**AN ANNOTATED ANALYSIS OF LOGIC  
IN THE 1992 REPORT, "THE ORIGIN AND HISTORY  
OF ALTERATION AND CARBONATIZATION OF THE  
YUCCA MOUNTAIN IGNIMBRITES,"  
BY J.S. SZYMANSKI**

**Nuclear Regulatory Commission  
Contract NRC-02-93-005**

**Bret W. Leslie**

**February 1994**

Figure 2-1. Logic diagram of arguments presented in Chapter 2

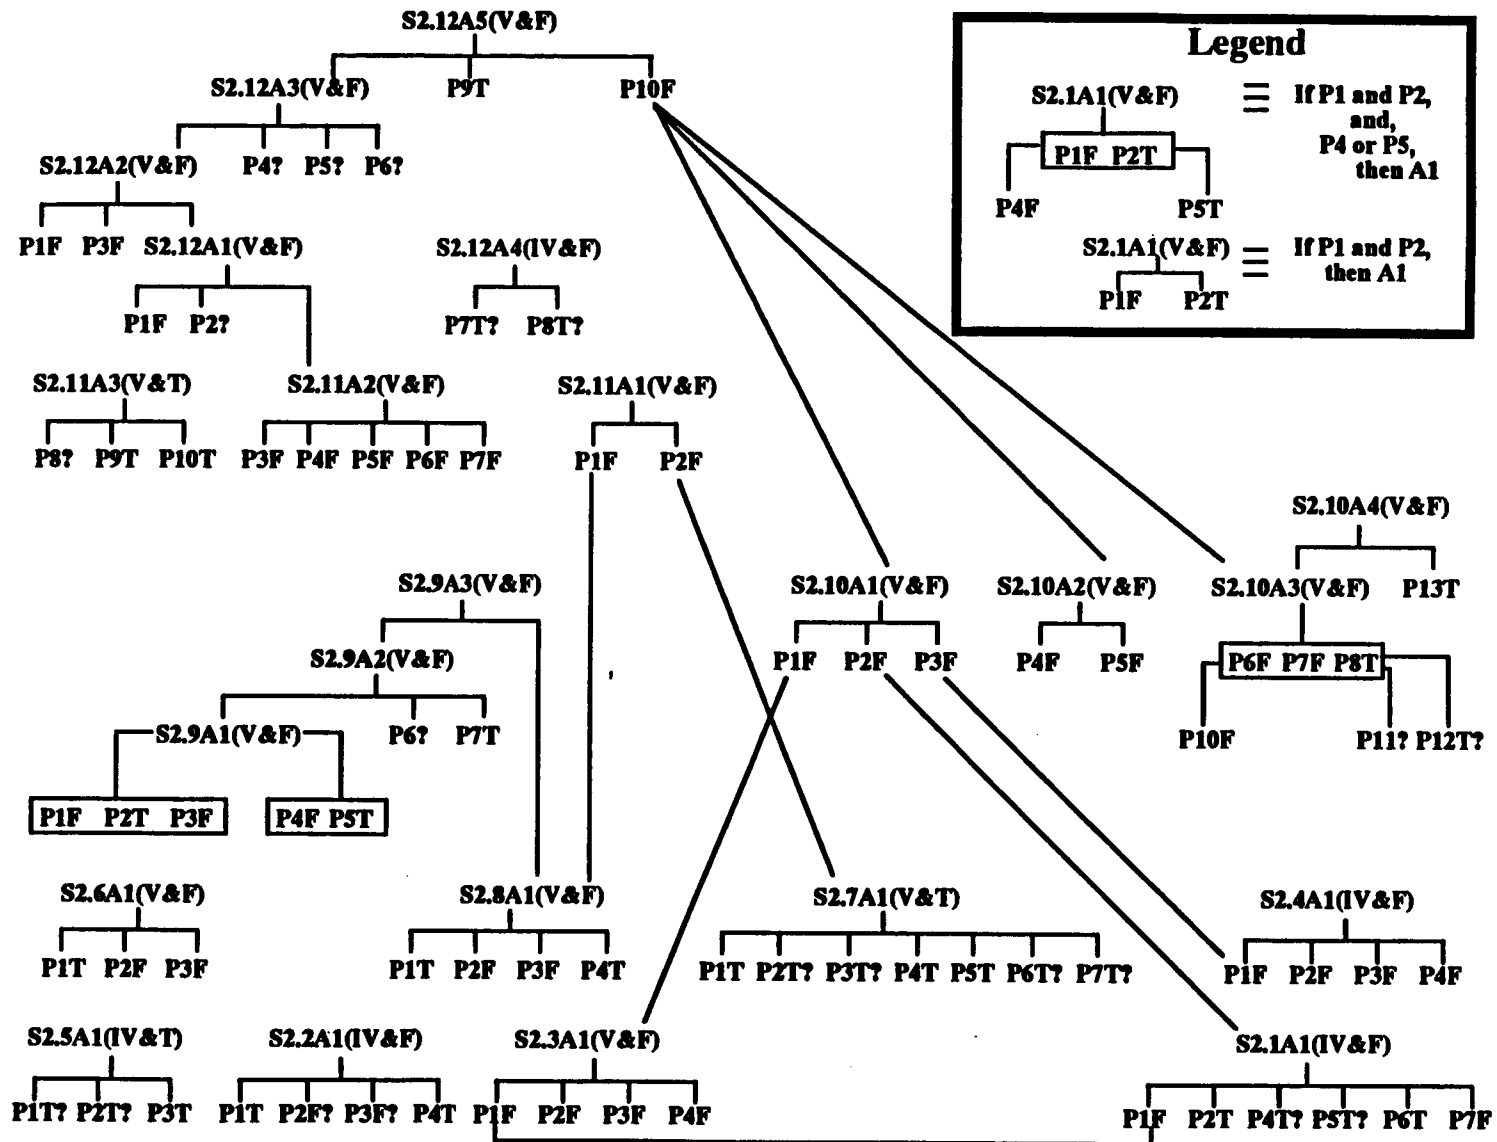
with local caldera-forming magmatic centers (P9); (iii) and the gradually evolving thermodynamic state in the Yucca Mountain region (P10, as described in Section 2.10). If these premises are true, then Szymanski's (1992) conclusion that the local geologic record should contain expressions of fairly young and distinctly more subtle hydrothermal deposits associated with intermittent conductively replenished hydrothermal systems can be accepted as true. In the analysis of argument A3 in this section, it was demonstrated that the premise that the geologic record of intermittent hydrothermal systems is principally expressed by accumulations of gangue minerals is false — so too, the conclusion of argument A5 is false. Premise P9 is adequately supported in the literature (Bish and Chipera, 1989; Broxton et al., 1987) and can be assumed to be true. Since the model upon which Szymanski (1992) builds his argument that the thermodynamic state has been gradually evolving is false (see analysis in Section 2.10), premise P10 is false.

As stated in the final paragraphs of Section 2.5 in Szymanski (1992), the rest of his document, and therefore the rest of this report, focuses on establishing whether fairly young and subtle hydrothermal deposits caused by conductively replenished hydrothermal systems exist in the Yucca Mountain area. From the discussion and analyses presented in this section of the report, it is clear there is no logical or scientific bases upon which to plausibly accept the existence of conductively replenished hydrothermal systems (characterized by intermittent ephemeral hydrothermal plumes) in the Yucca Mountain region. The conclusions for all subsequent arguments developed by Szymanski (1992) which require that conductively replenished hydrothermal systems (characterized by intermittent ephemeral hydrothermal plumes) exist in the Yucca Mountain region will be false.

Figure 3-1. Logic diagram of arguments presented in Chapter 3

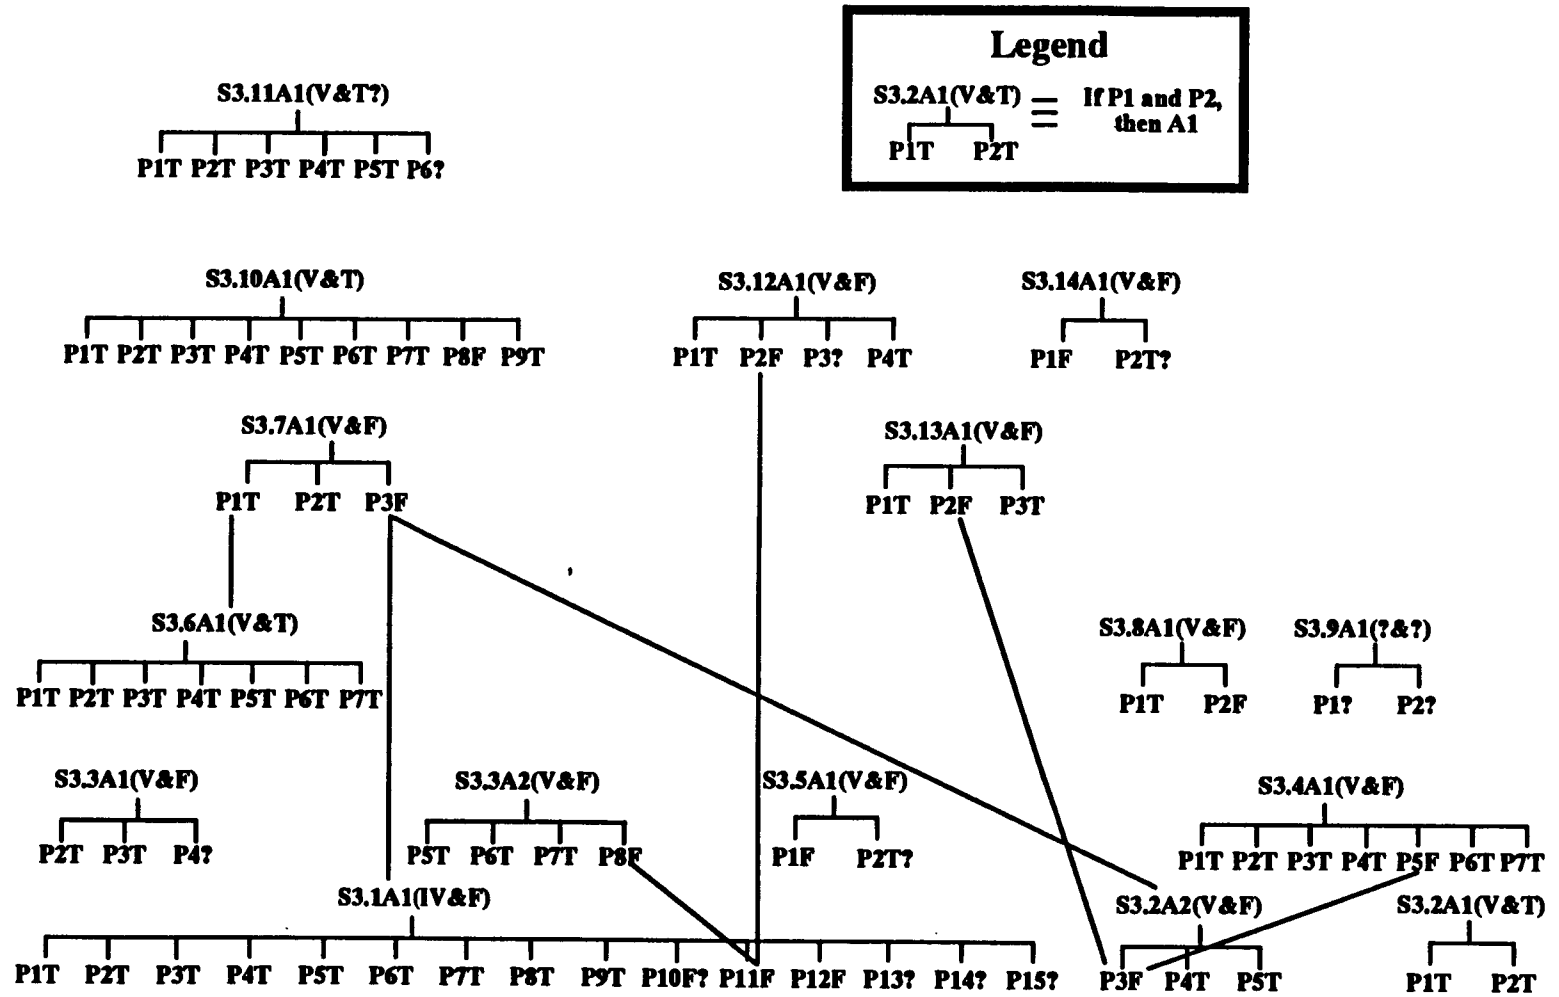
The assertion of argument A1 that the mosaic breccias at the topographic surface may be formed by hypogene fluids requires that premises P1 and P2 be true, if the conclusion is to be accepted. Since P1 is false, the logically correct form of argument A1 requires that the conclusion not be accepted. Szymanski (1992) offered no evidence of mineralogical purity of the mosaic breccias other than pure assertion, while published analyses of the breccias indicate (Stuckless et al., 1992; Everden, 1992) they are impure (> 30%).

Although Szymanski (1992) asserted the upwelling possibility can rationally explain every single field observation of calcretes, sinters, bedrock veins, and mosaic breccias, it is clear from this analysis of the logic used by Szymanski (1992) in Chapter 3 of the report, that many irrational assumptions must be made and several logical inconsistencies are present. This chapter acts as a foundation for subsequent chapters in his report (1992) and is the most poorly scientifically supported section. His style of argumentation in this chapter relies on blind assertion, without sufficient or adequate documentation, to test his premises/affirmations. Many of his most critical declarations conflict with observations and published models of supergene pedogenic mineral formation in arid regions. His foundation (calcretes, sinters, bedrock veins, and mosaic breccias may be formed via hypogene processes) for many arguments in subsequent chapters (Szymanski, 1992) was primarily based upon this assertion — not supported by available evidence — and should not be accepted as true.

Figure 4-1. Logic diagram of arguments presented in Chapter 4

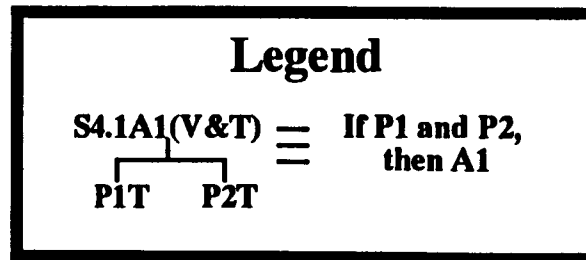
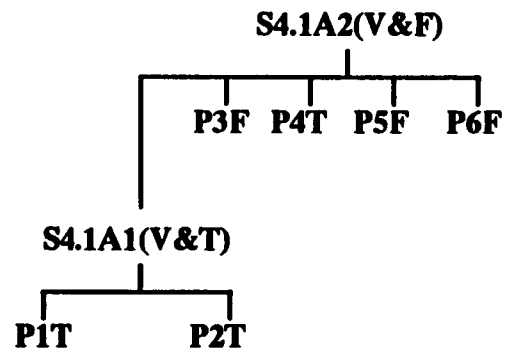
Szymanski's (1992) construction of argument A2 was valid. Premise P4 is true and requires no further discussion. However, the faulty assumptions P3, P5, and P6 require clarification. Premise P3, as implied by Szymanski (1992) requires that euhedral zeolites formed late in the Yucca Mountain deformational history. However, formation of euhedral zeolites must occur later than faulting of the Topopah Spring Member of the Paintbrush Tuff. The absolute age of the faulting which produced the faults upon which the zeolites grow is not known. Unless the euhedral zeolite sample is dated, the age of formation of the zeolite cannot be known. It has been argued by Carlos et al. (1991) that since most of the movement at Yucca Mountain took place prior to 11.6 Ma (Levy, 1991), then zeolites may have formed during hydrothermal alteration associated with the Timber Mountain caldera eruption of the Rainier Mesa Tuff at 11.6 Ma. Premise P5 assumes that most vadose zone mineralization, including calcite formation, is due to hydrothermal processes. This premise was discussed in detail in Section 3.1

of this report and was demonstrated to be false. Finally, premise P6 requires that a decreasing flux of mantle-derived magma be generated with time. As discussed in Section 2.4, the theory that only asthenospheric magma can describe the observed basalt and silicic volcanism was argued to be false since the basaltic magmatism may not actually have an asthenospheric geochemical character (Livaccari and Perry, 1993). It should be noted that epigenetic strictly means that a deposit forms later than the enclosing rock and does not have any larger meaning with regard to absolute timing of the mineralization. The conclusion that some of the observed mineralization and alteration phases found in rock cores are records of intermittent activity of hydrothermal systems driven by conductively replenished heat sources (Szymanski, 1992) is false.

Figure 5-1. Logic diagram of arguments presented in Chapter 5

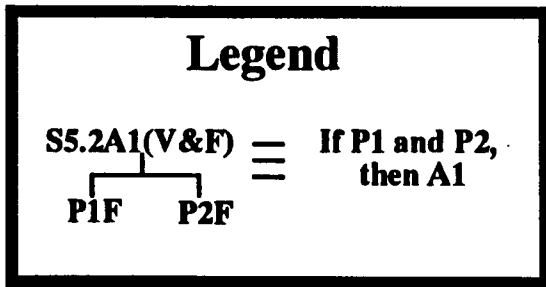
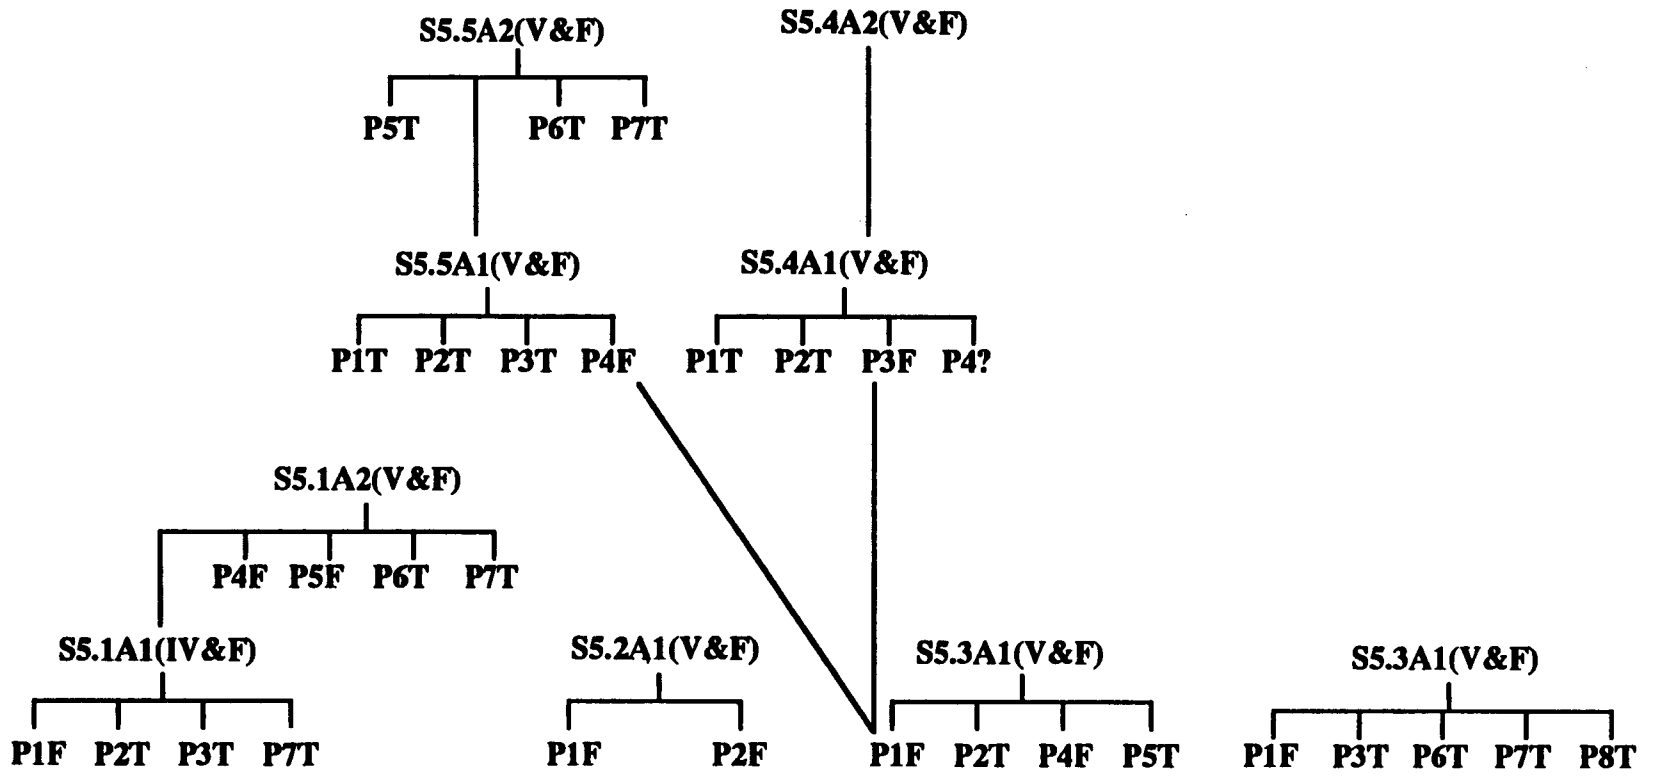
It is only based upon his conclusion (Szymanski, 1992) that vadose zone ignimbrites were influenced by epigenetic hydrothermal processes which could have contained large quantities of dissolved CO<sub>2</sub> can assertions in the remaining sections be partially supported by Szymanski (1992). Since Szymanski's basic conclusion of his Section 5 (Szymanski, 1992) was flawed and cannot be accepted as true, resulting arguments which are dependent of the truth of his conclusion will also be similarly adversely affected. Also, any conclusions which relied on his assertion that vadose zone ignimbrites were influenced by epigenetic hydrothermal processes (which could have contained large quantities of dissolved CO<sub>2</sub>) cannot be considered to be true.

Figure 6-1. Logic diagram of arguments presented in Chapter 6

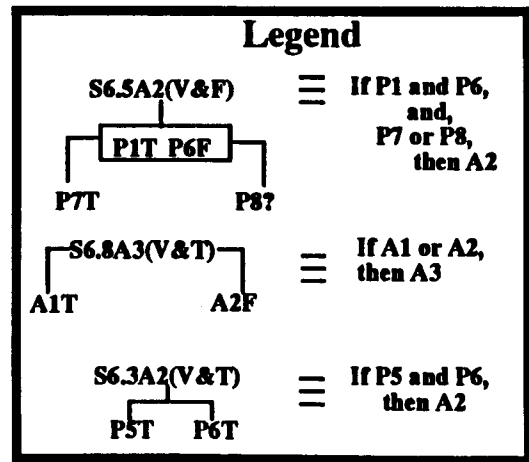
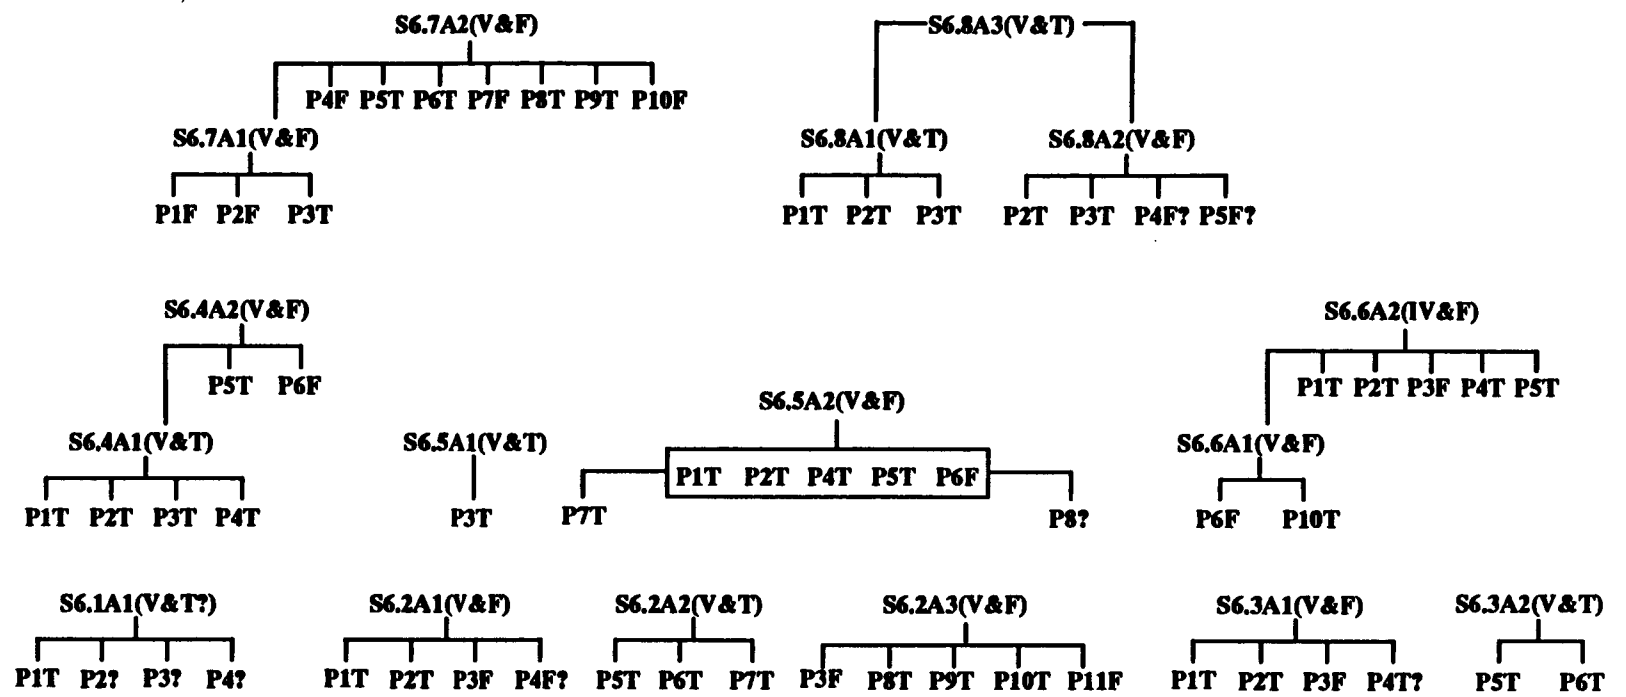
Based upon the valid logical construction of argument A3, only the truth of arguments A1 or A2 must be ascertained before the conclusion can be accepted as true. As was demonstrated in the analysis of argument A1, the conclusion of that argument indicated it could be accepted, and thus the conclusion of A3 can be accepted. The result of the analysis of logic used by Szymanski (1992) indicated there is no conclusive evidence which may be solely derived from the presence of dated zircons in the AMC breccias regarding origin of pedogenic deposits. Since the hypogene fluids would have to be traveling at large enough speeds from great depths (> 8 km for 30 °C/km geothermal gradient), provided to carry the zircons, it is remarkable that the evidence of destruction of these explosive fluids is not preserved in the deposits (Stuckless et al., 1992; Everden, 1992). It should become more clear if supergene pedogenic processes can cause the incorporation of anomalous (discordant) zircons when further characterization of the detrital dust flux is completed. Nevertheless, the more likely scenario for the incorporation of zircons into pedogenic deposits is by supergene processes.

Figure 7-1. Logic diagram of arguments presented in Chapter 7

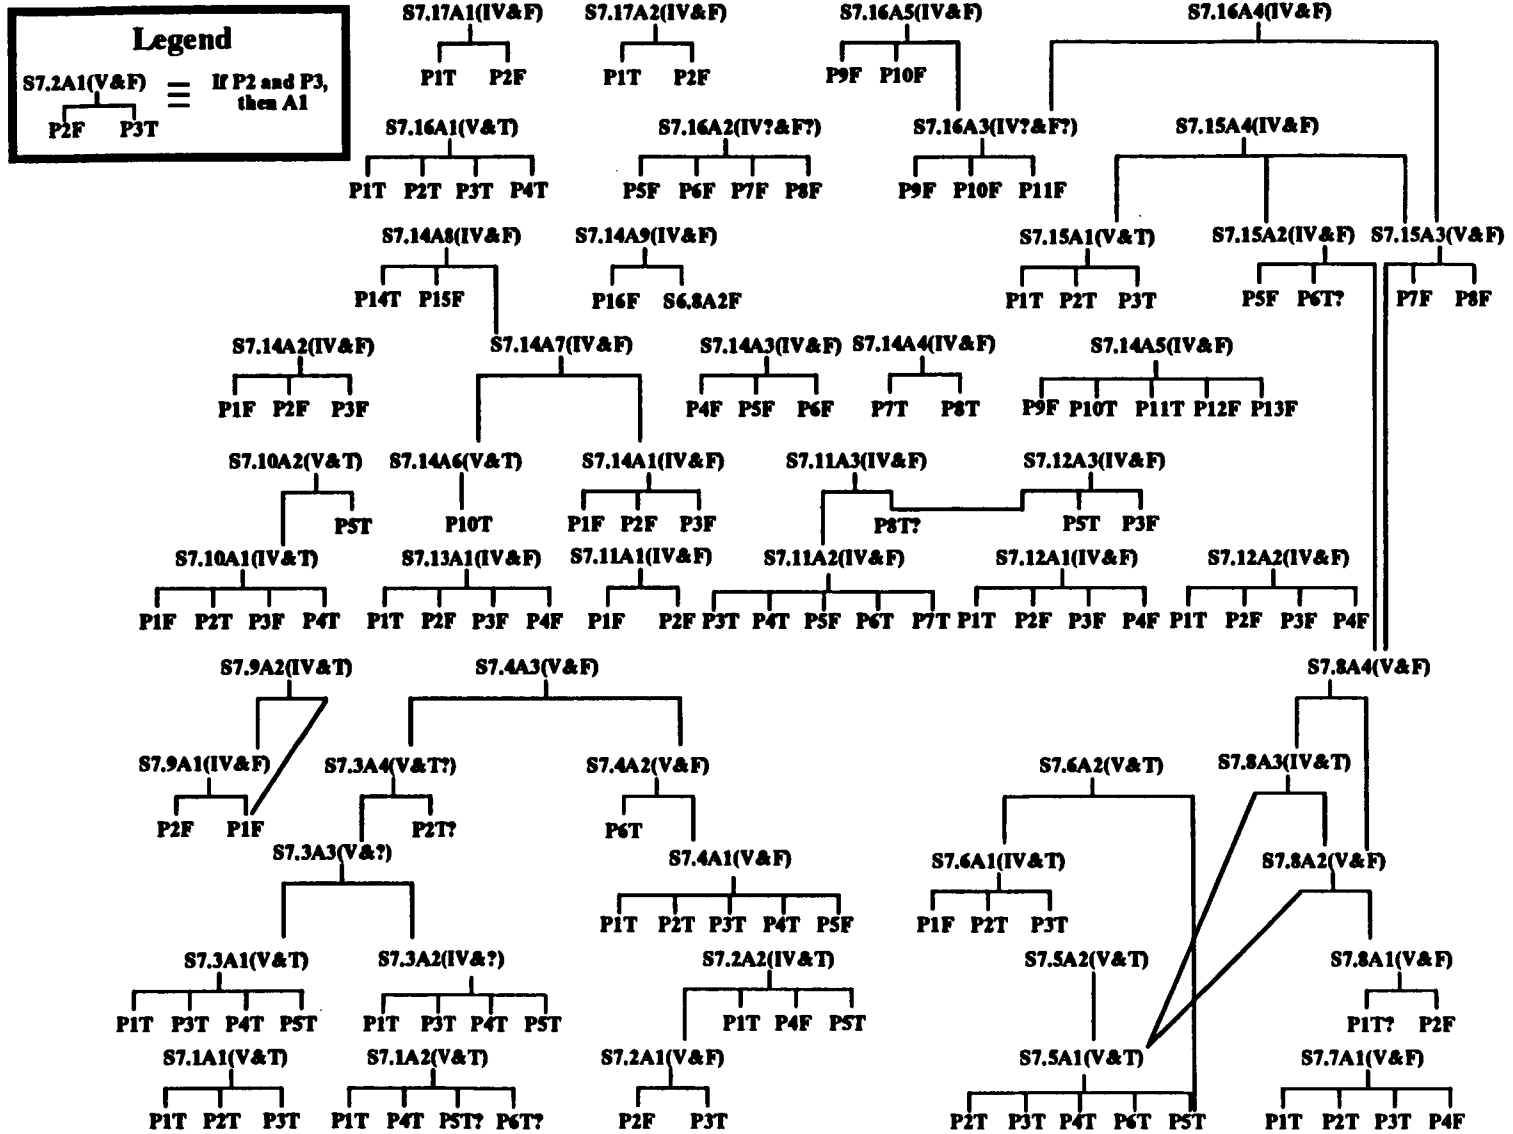
Premise P1 is true (Bish, 1989; WoldeGabriel et al., 1992; Broxton et al., 1987). P2 is false since the zeolite analyses do not reflect their age of formation. Szymanski (1992) asserted that the age of formation of the zeolites was temporally correlative to local magmatic history. Szymanski's (1992) interpretation of the term local meant any magmatic activity within 100 miles of Yucca Mountain. The logical inconsistent nature of this definition was presented in Section 2.2.3. In conclusion, there is no reason to believe Szymanski's (1992) assertion that the K/Ar ages of the epigenetic clinoptilolites adequately reflect the timing of the main episodes of hypogene alterations.

Since argument A2 relies on the same premises as A1, the same analysis of logic may be used. Argument A2 is invalid, premise P1 is true, P2 is false, and there is no logical reason or scientific evidence which can be used to support Szymanski's (1992) assertion that the low grade metasomatic zeolitization expresses and records episodically-continuous, or intermittent hydrothermal metamorphism. At this point it can be concluded that any further arguments developed by Szymanski (1992) which rely on premises that include inferences on K/Ar ages of clinoptilolites may be summarily dismissed.
